PROPOSAL FOR DRAFT AMENDMENTS TO REGULATION No. 36

Transmitted by the Expert from Germany

Figure 10

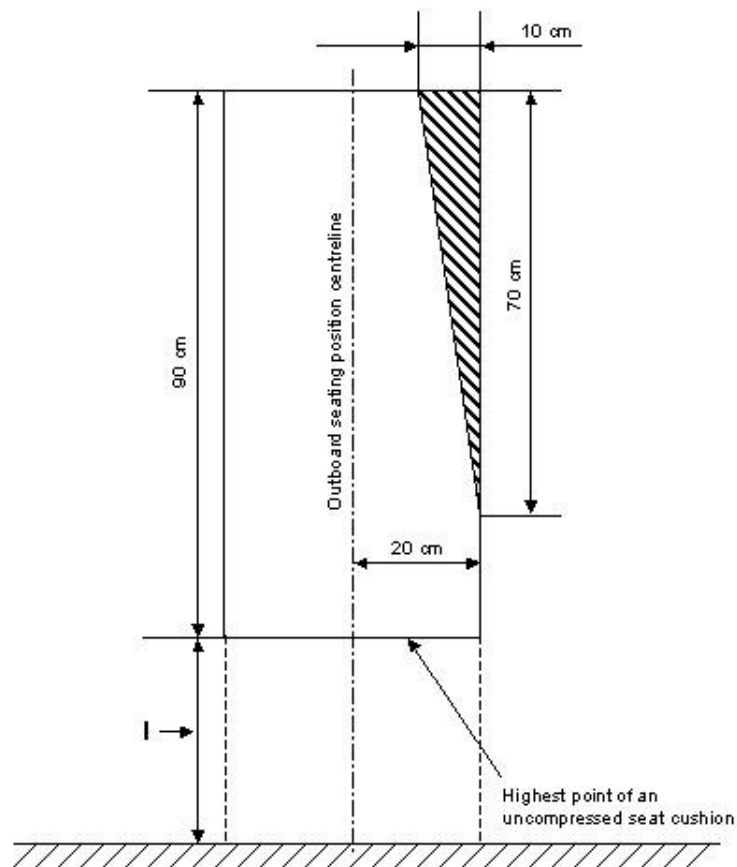
Paragraph 5.7.8.6.2.2., amend to read:

“5.7.8.6.2.2. Intrusion of a structural member provided that the intrusion is included within a triangle whose peak is situated ~~65 cm from the floor~~ **70 cm from the top** and whose base is 10 cm in width and situated in the upper part of the space in question, adjacent to the side wall of the vehicle (see annex 3, figure 10).”

Annex III, Figure 10 amend as shown:

Justification:
The alteration corrects figure 10.
The requirements of figure 6

are transferred to figure 10 to make clear that the general prescriptions of paragraph 5.7.8.4 apply also to paragraph 5.7.8.6.2.2.

As there are different values for „l“ the former method to define the starting point for the triangle representing the permitted intrusion needs to be revised, in order to establish equal conditions for all of the different values. This is achieved by measuring from the top of the minimum height above the seat and leaving the geometry of the triangle unchanged.
